7216 AURORA AVE N
DESIGN RECOMMENDATION
10 FEBRUARY 2022
SDCI Project: #3034281-LU

Administrative Design Review

ADMINISTRATIVE EARLY DESIGN GUIDANCE 2 - RESPONSE MATRIX

MASSING

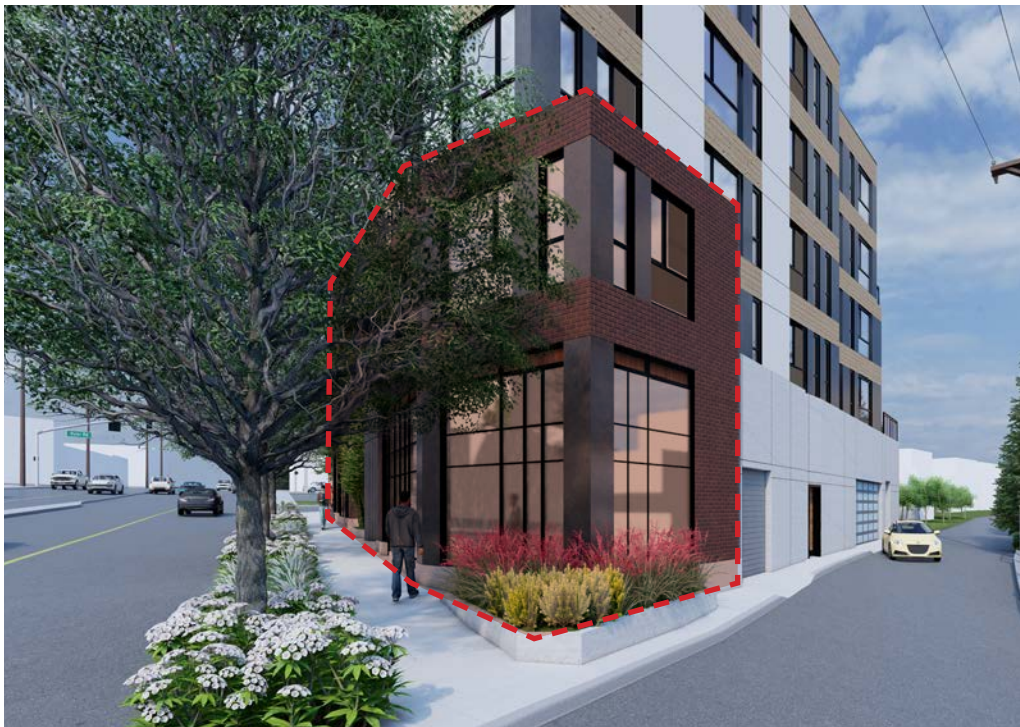
- 1. Staff supports the applicant’s massing option that presents a two-story base along the street edge and varied upper levels that offer scale and legibility. (CS3-A-1, DC2-A-2)

- 1. Two-story base has been developed to simplify the storefront system further into a more linear and cohesive street edge. The initial design was developed as a series of individualized storefront panels, the redesigned pedestrian edge connects these storefront sections into a cohesive linear element which abuts the sidewalk. This creates a much clearer residential and commercial edge for the building.

GROUND LEVEL USES & ENTRIES

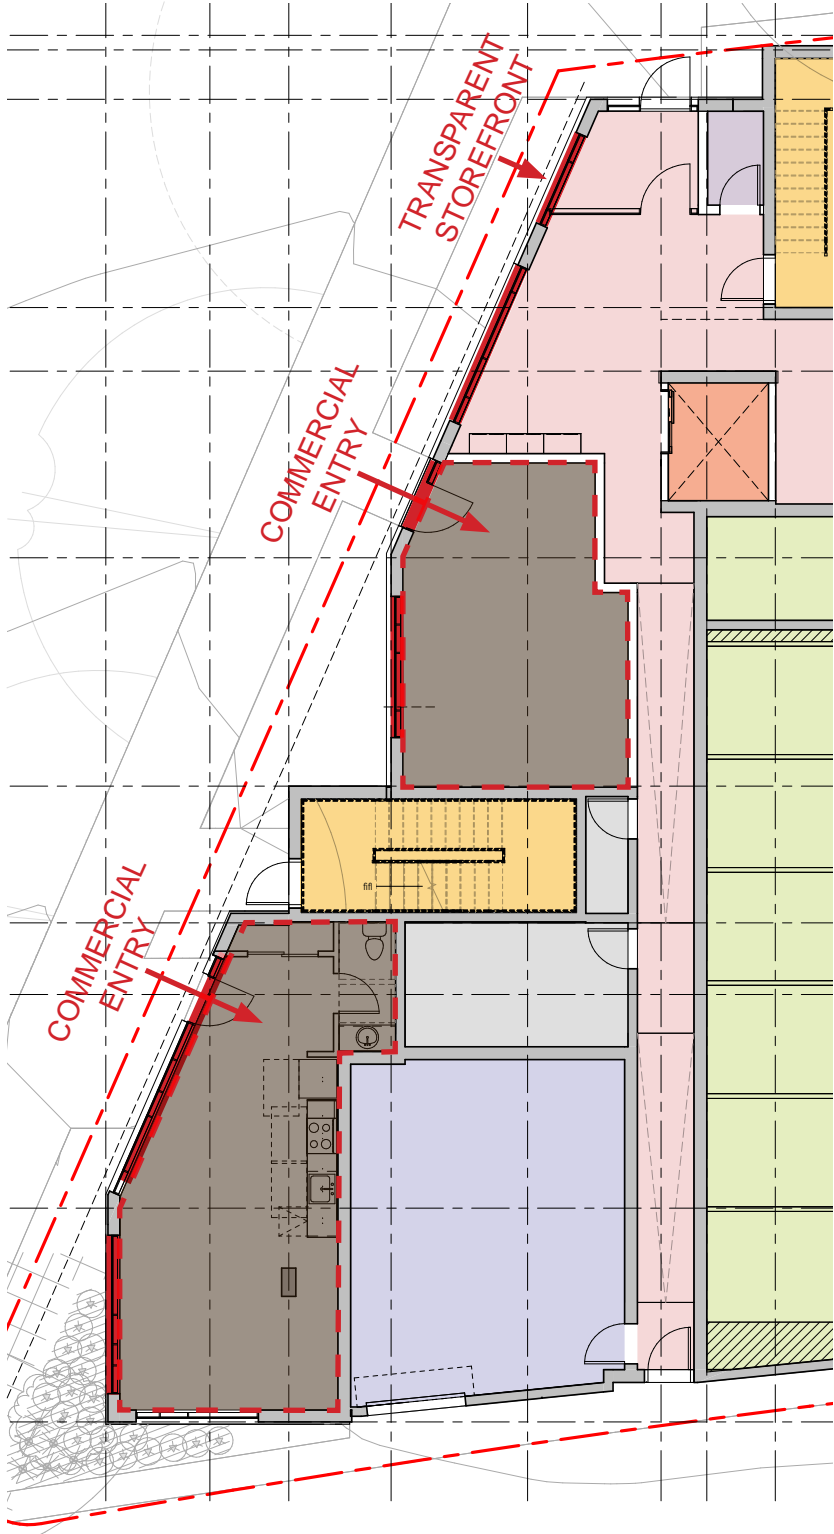
- 1. The ground level uses continue to be problematic in that several ‘back of house’ uses are located along the street...
 - i. One of the two live/work units has direct access to the street while the other causes the visitor to walk through three doors before reaching the second live/work space...
 - ii. The Design Guidelines speak to porous retail edges...
- 2. Staff appreciates the applicant relocating the residential lobby entry...
- 3. It is challenging to distinguish between the live/work entry...

- 1. The first floor has been redesigned in order to express the more public side of the building. Bicycle parking has been relocated to the parking garage and both commercial spaces have been elongated in order to lengthen and create a storefront which is more cohesive and has a larger area of coverage. The stairwells serve as a verticle element that breaks up the rythm of the upper sections of the building as well as connecting the upper roof down to the ground level.

- i. Commercial spaces are designed to exclusively enter through direct street access off Aurora.
 - ii. The first floor revision has increased the storefront transparency coverage at the retail edge by increasing the coverage by the commercial areas. The facade along Aurora is now 66% transparent and the setbacks along the Aurora facade are now occupied by landscaping planters to decrease the emphasis on these secondary elements.

- 2. The residential entry remains oriented towards Keen. This entry has been further emphasized by a linear canopy which covers both the commercial space and turns the corner to Keen way.

- 3. Live/work units are removed and replaced with commercial spaces. The entry to these spaces has been reoriented to Aurora.

FACADE COMPOSITION

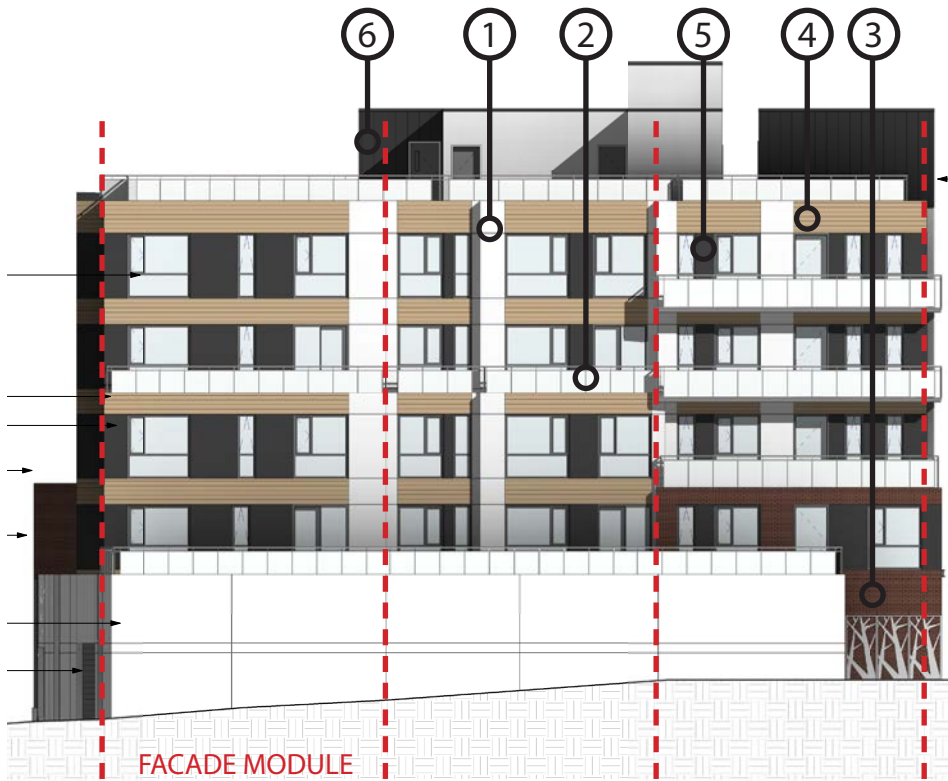
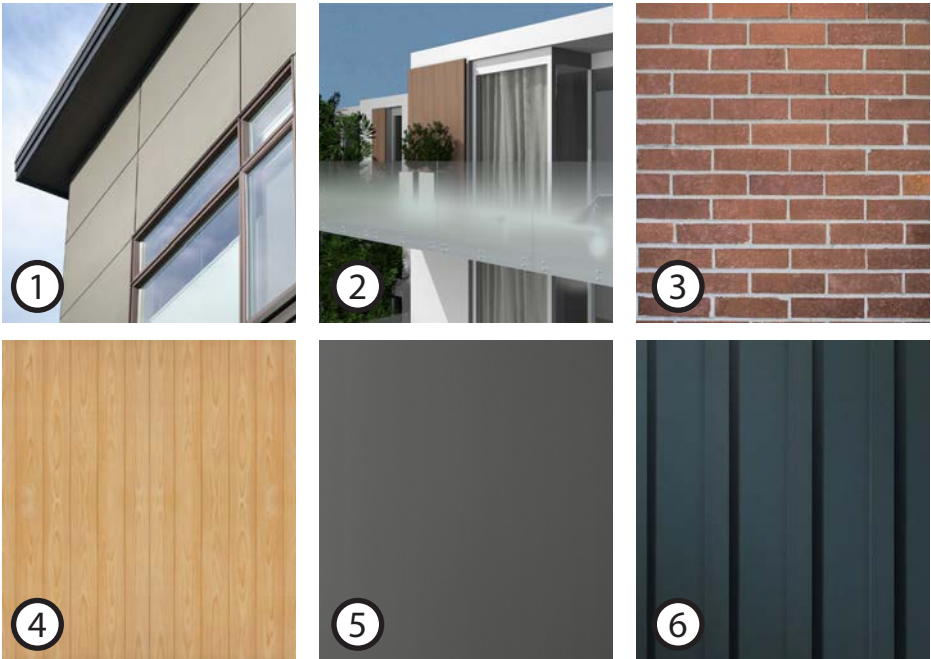
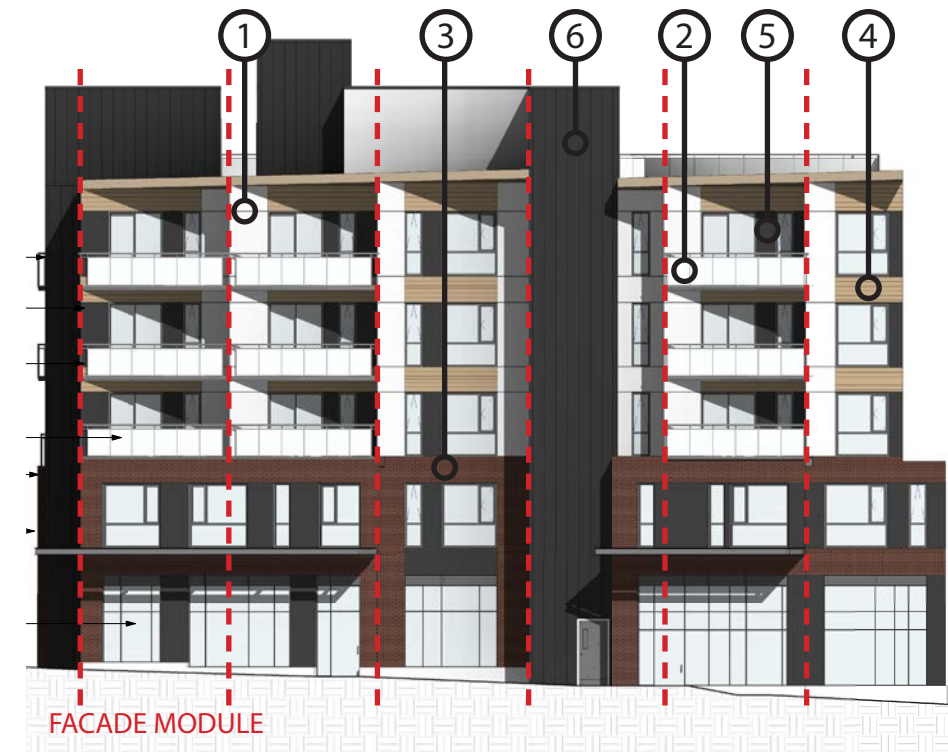
- 1. Although staff appreciates the applicant’s efforts to provide scale and visual interest on the upper levels, staff acknowledges there appears to be little cohesion and hierarchy of elements and the application of materials should be simplified to strengthen the design concept. (DC2-B-1)
 - i. The precedent image on page 22 of the design review packet is successful in that the roofline is flush with carved voids clad in wood and the addition of balconies help accentuate the voids. Small revisions to the west façade to the concept and composition to help clarify the form will be successful in creating a simple, cohesive project. (DC2-B-1)

- 1. The facade materials and composition has been redesigned and recomposed to create more evenly spaced bays and reduce the number of materials and secondary elements at each facade. Each facade has been recomposed to create a more cohesive design through the entire project. The project now has two clear languages; the brick and storefront base which extends to the second floor and the upper floors which is composed of white FCP, wood-look accent panneling, and dark metal panel between windows.

- i. Roofline has been redesigned to be aligned across the entire facade along Aurora and the roofline has been reduced back to create a more clear connection between the line of the roof and the carved voids along the facade. Balconies hav also been added to the facade in order to express a more clear horizontal composition of the facade. The simplification of all facades as detailed above has also created a more clear and cohesive design.

SINGLE FAMILY ZONE TRANSITION

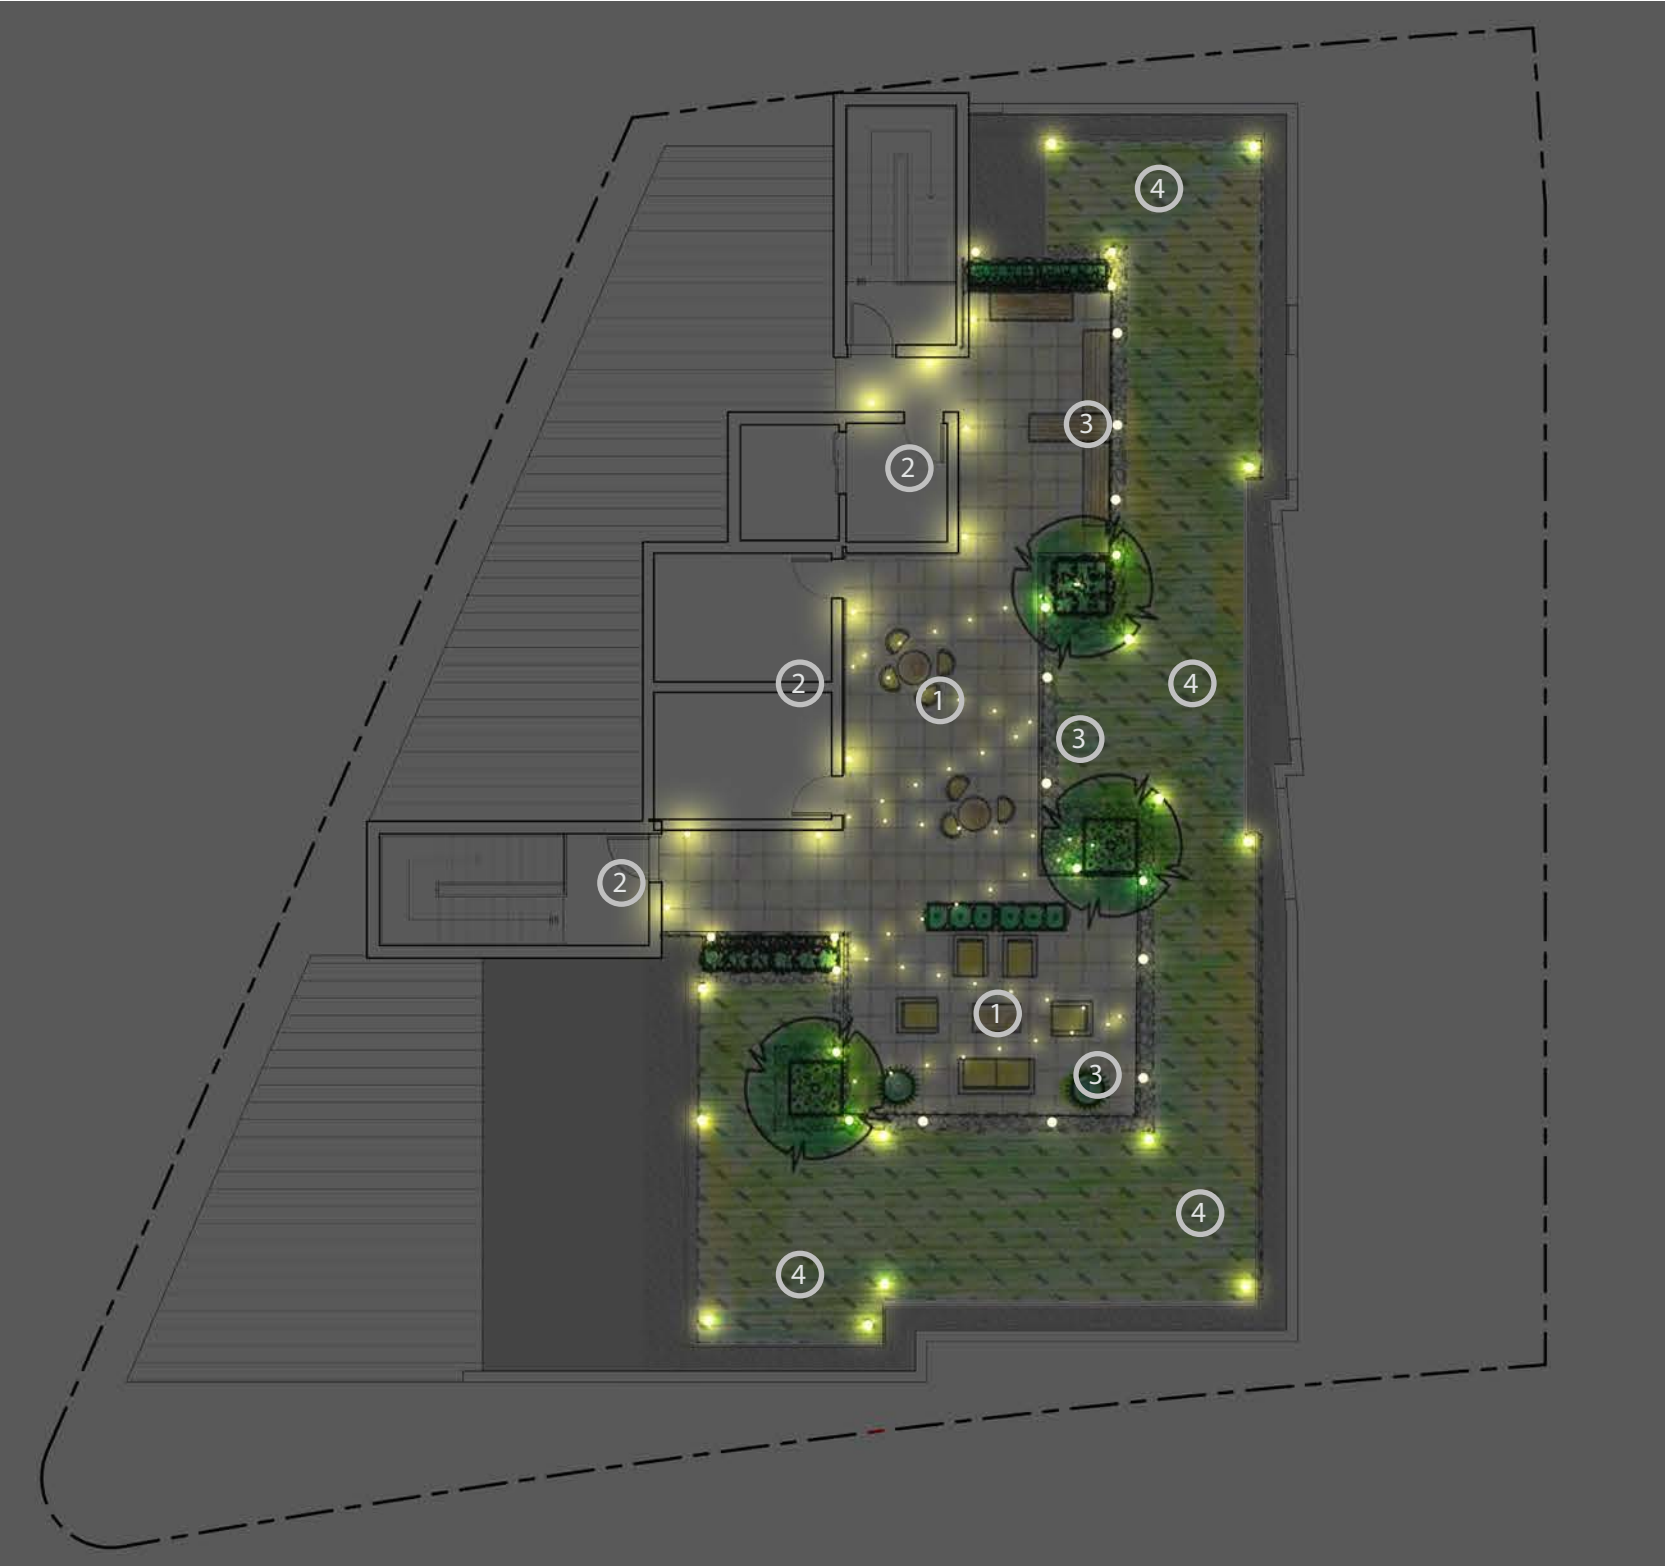
- 1. Staff supports the applicant’s massing option that presents a two-story base along the street edge and varied upper levels that offer scale and legibility. (CS3-A-1, DC2-A-2)

- 2. This wall currently abuts a high fence on this property as well as vegetation which significantly decreases it’s presence. The wall itself will be composed of high quality concrete with reveals.
